WILLIAMSON COUNTY, TEXAS

CHANGE ORDER NUMBER: 8

Project:	<u>Great Oaks Dr. Improvements</u>
Roadway:	<u>Great Oaks Dr @ Brushy Creek</u>
CSJ Number:	<u></u>

Great Oaks Drive Improvements Williamson County Project No. T4327

CLEARANCE SIGN 7-1
STRUCTURAL DETAILS

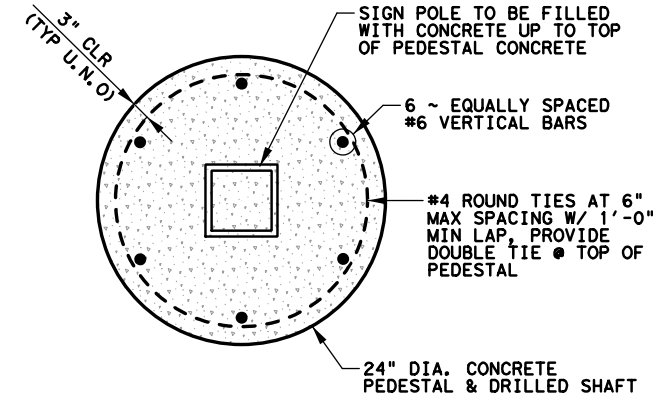
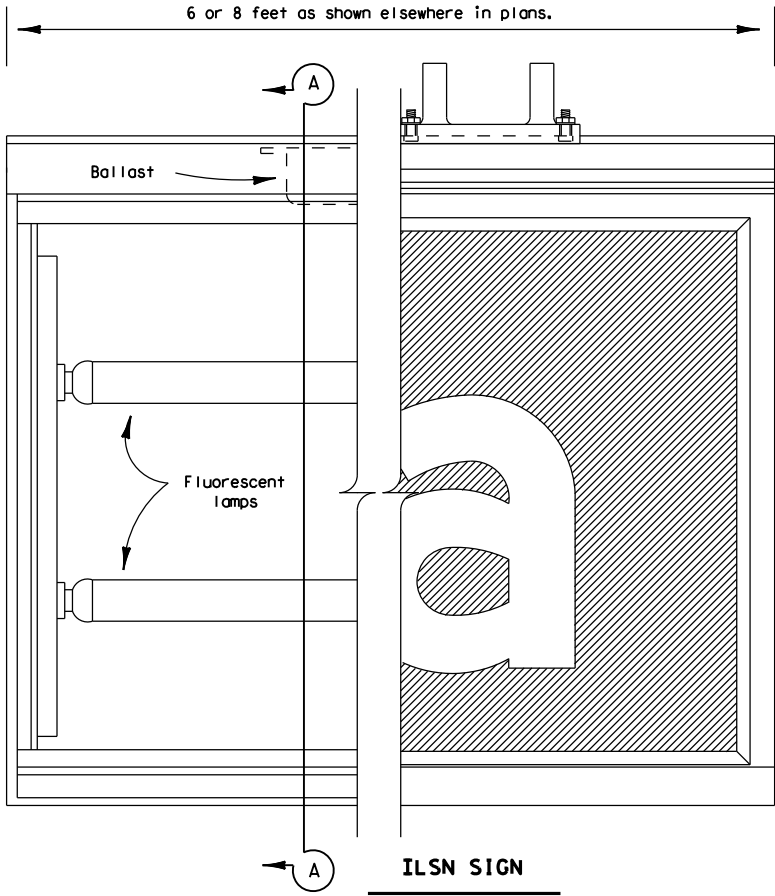
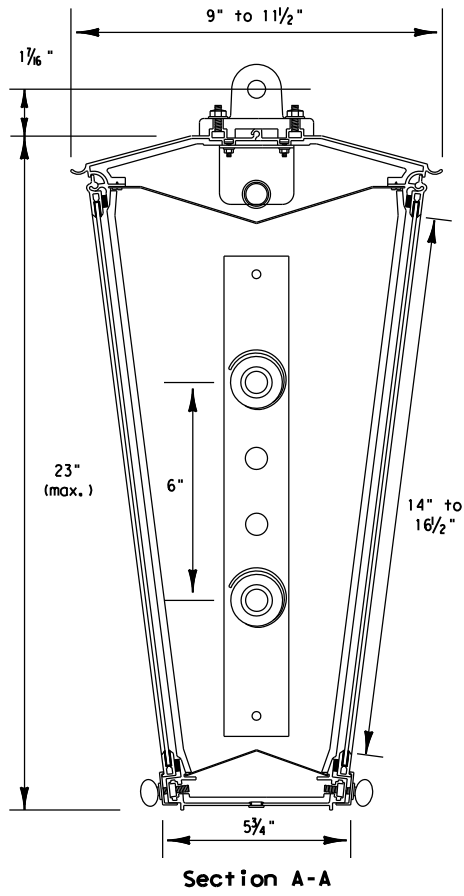
REV-1 CONSISTS OF NEW
STRUCTURAL DETAILS FOR
CLEARANCE SIGN 7-1

① BOTTOM OF DRILLED SHAFT SHALL BE SOCKETED 2' MIN INTO LIMESTONE.

RFI 34 - ATTACHMENT #1

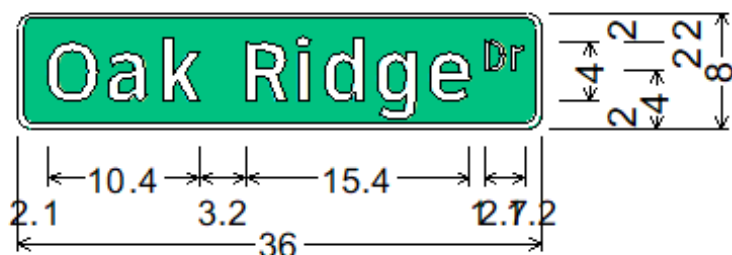
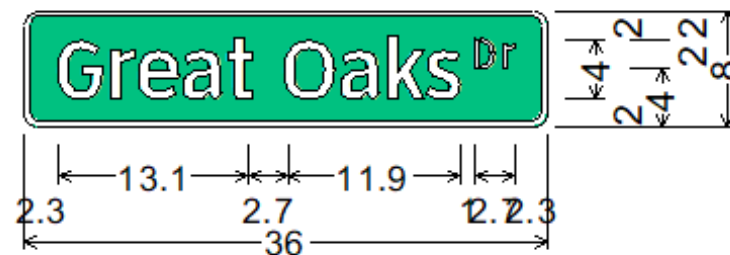
Optional Street Name Signs at Oak Ridge At-Grade Intersection
(signs should have 4" or 6" tall lettering - both options shown below)

[4" lettering option](#)
